Locomotive Workshops

Mirvac

Response to SSDA Submissions Package

May 2018

Loading Dock - Elevation A

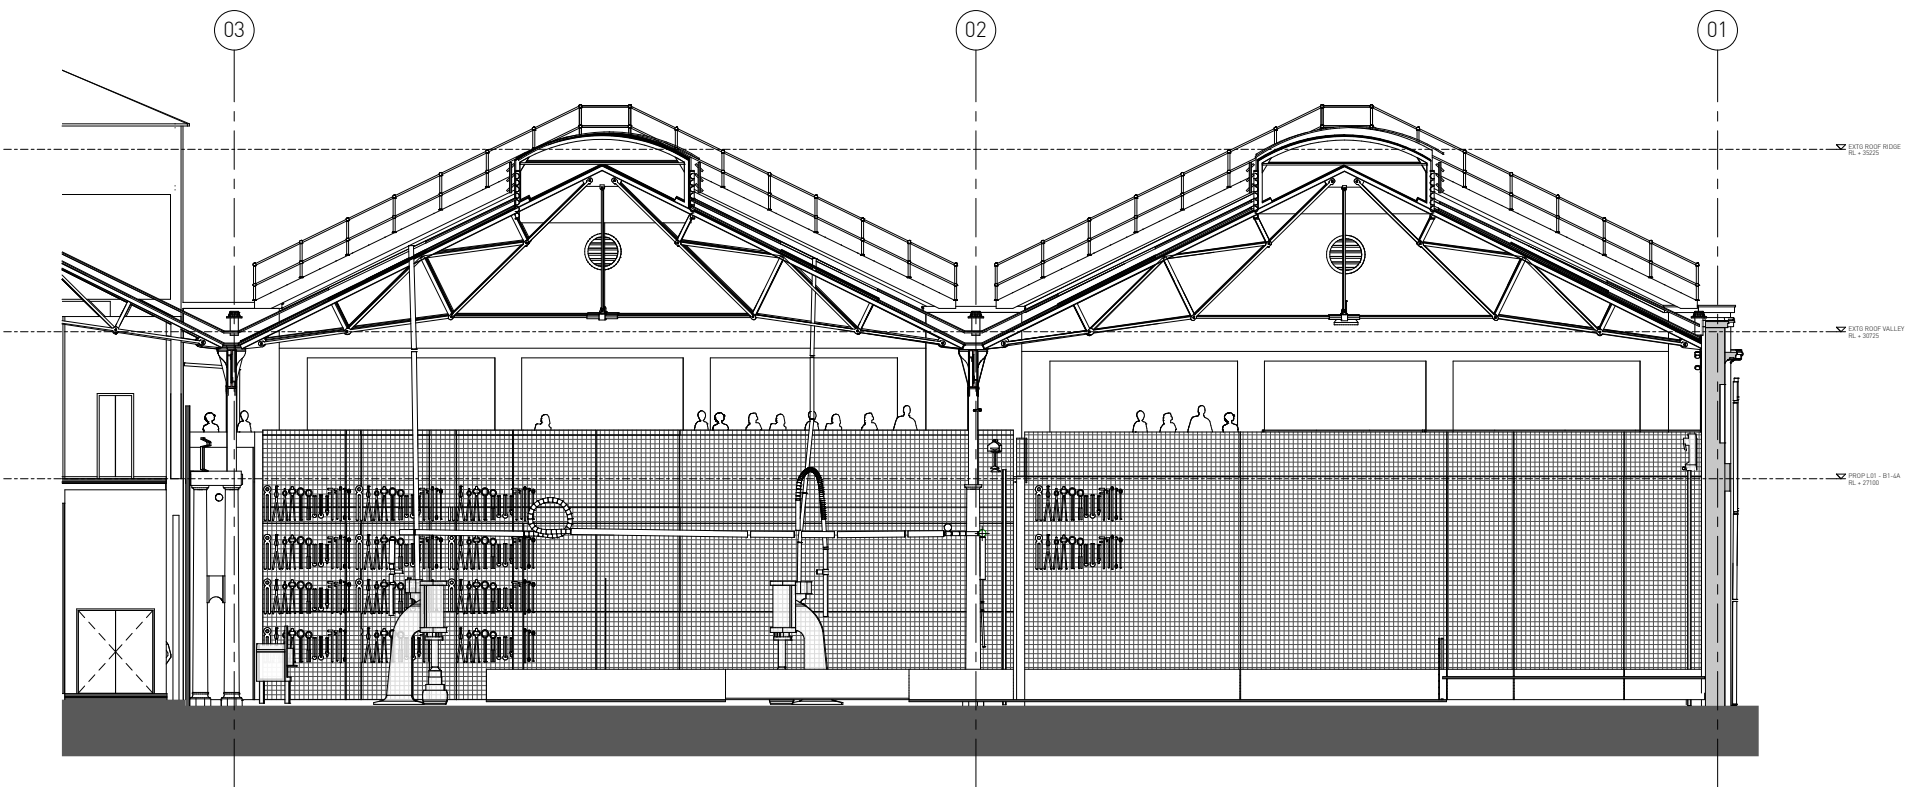
The walls surrounding the Davy furnace are to be glazed to ensure maximum vision through the dock and to the furnace from the public realm. Given the functionality of the loading dock, protective barriers will be in place on the dock side of these walls to protect both the walls and the heritage equipment from vehicles. These barriers are to be designed to be as minimal as possible, utilizing railing elements rather than solid barriers.

Vehicle parking zones have been shifted to ensure that when parked the vehicles will not obstruct views from the public realm to the Davy furnace. The compactor and waste rooms are located out of sight from publicly accessible areas.

Where back of house loading dock areas are bounded by heritage walls and columns, a new protective wall lining is proposed on the dock side to protect the heritage fabric from wear and tear. Refer to the attached diagrams for indicative details.

Roof Platforms - 3D Sectional View

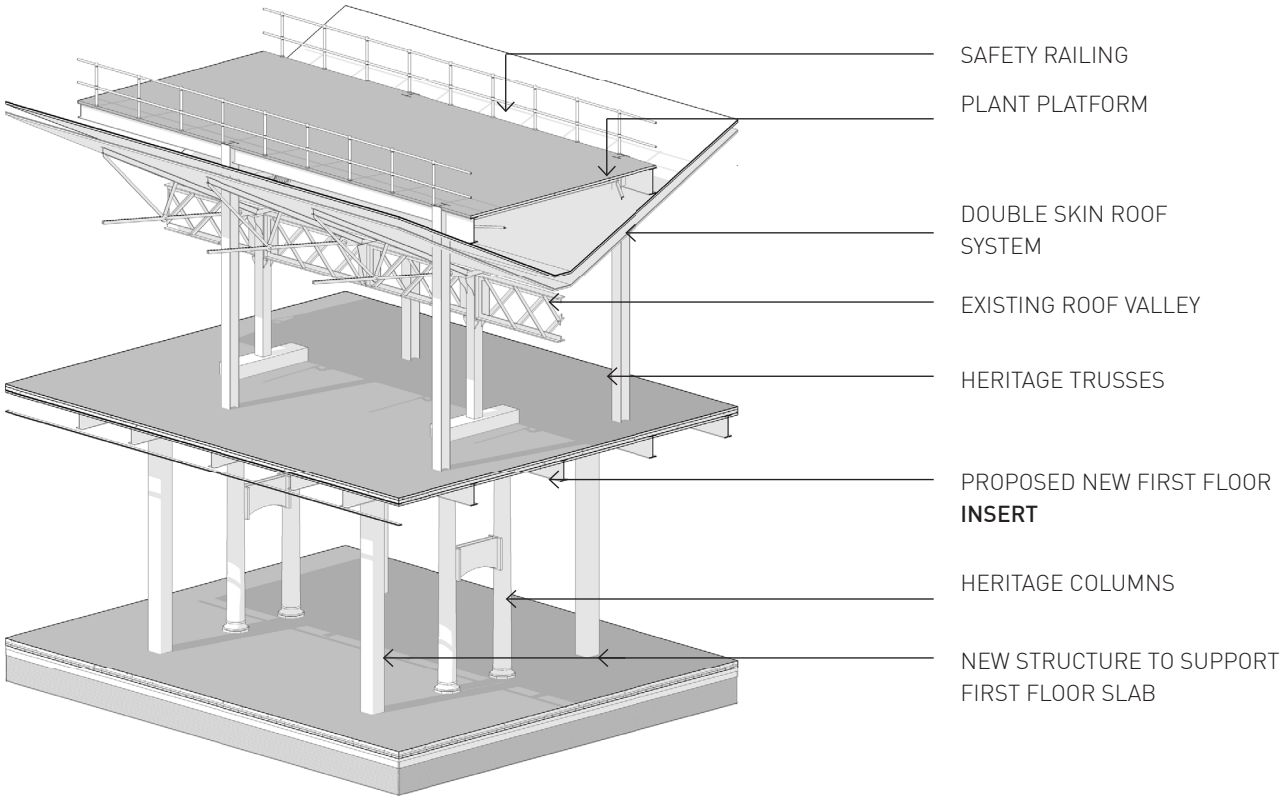
Roof plant platforms are set back from the building perimeter and will not be visible from the public domain, as clearly indicated on page 41 of the Design Report.

The platforms are to be supported by new columns which are to transfer the load to bear on the supports for the new first floor slab in Bays 3-4A. As such no additional groundworks will be required as a result of the platforms. The platforms are to be accessed via new access stairs leading from the fire egress stairs in Bay 3 and Bay 4A.

Roof Plant Platforms - Excerpt Plan

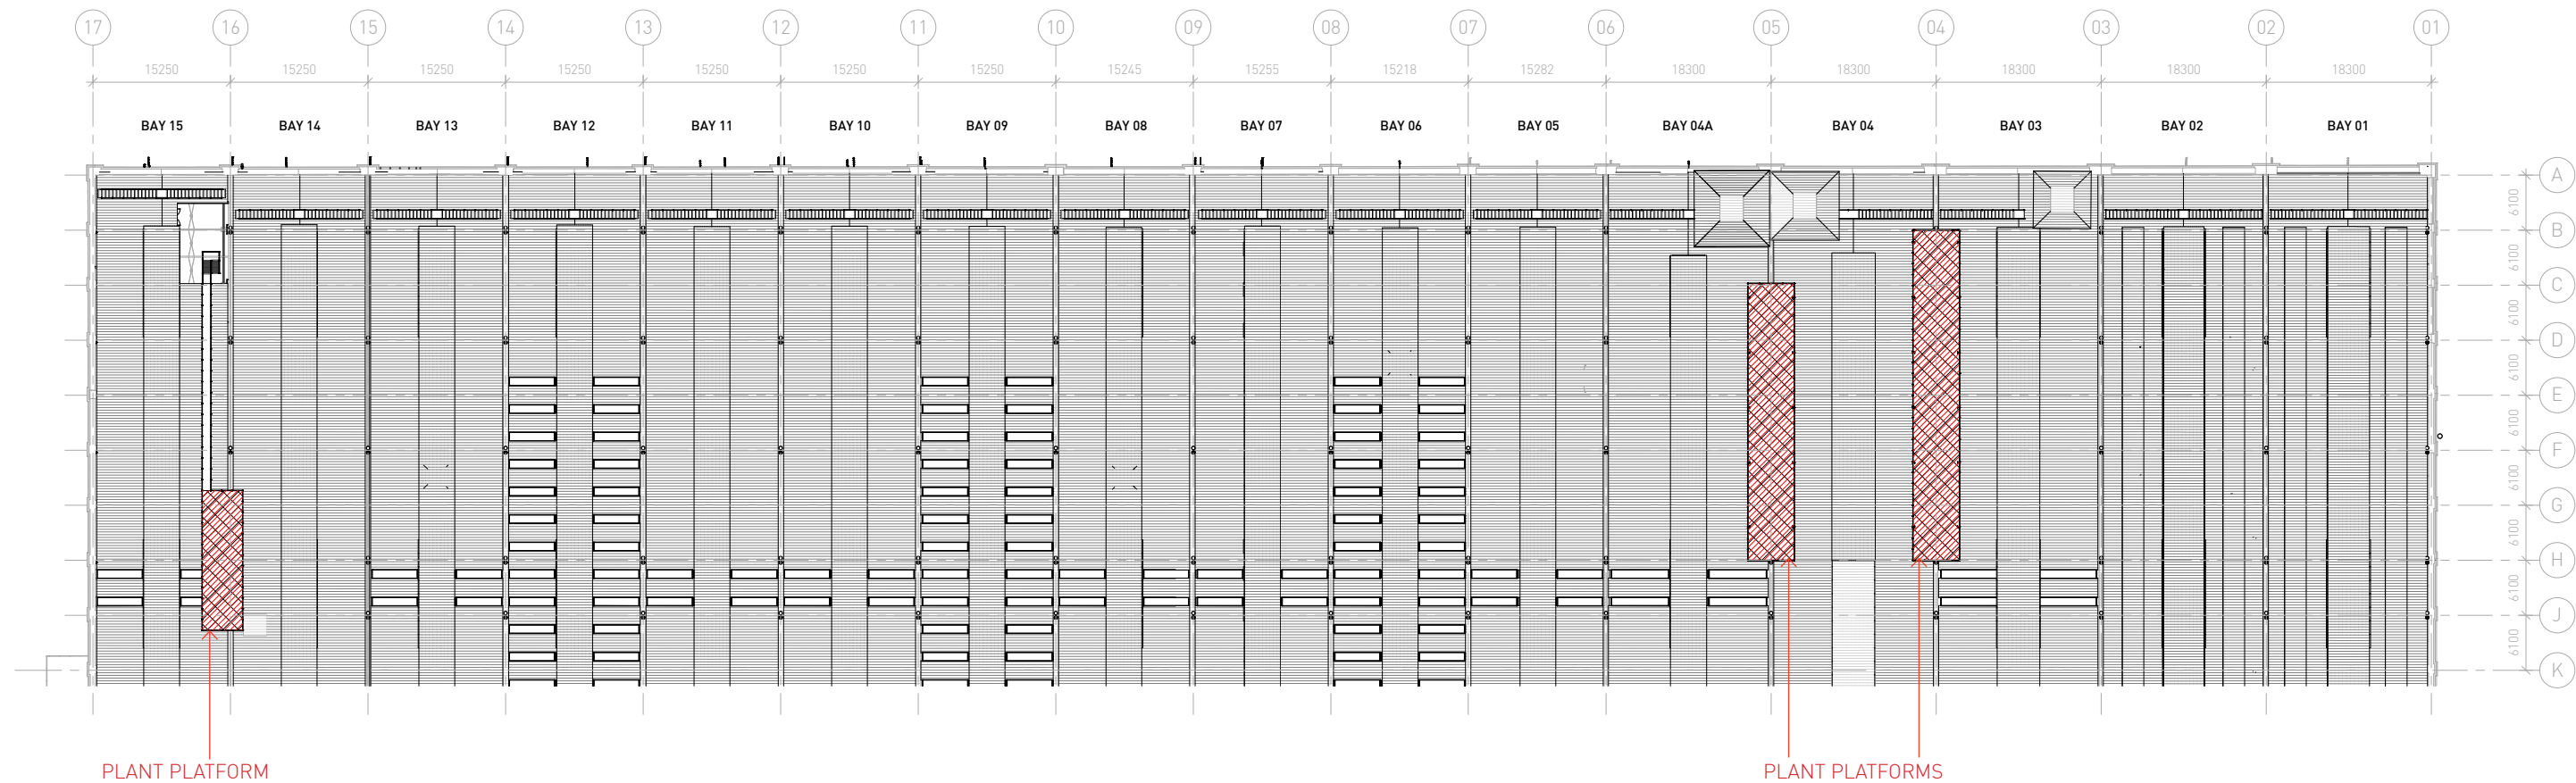
A third plant platform is proposed in the valley between bays 14 and 15, its location at grid line H is well concealed from view from the public domain. This platform is support by new columns to go to ground.
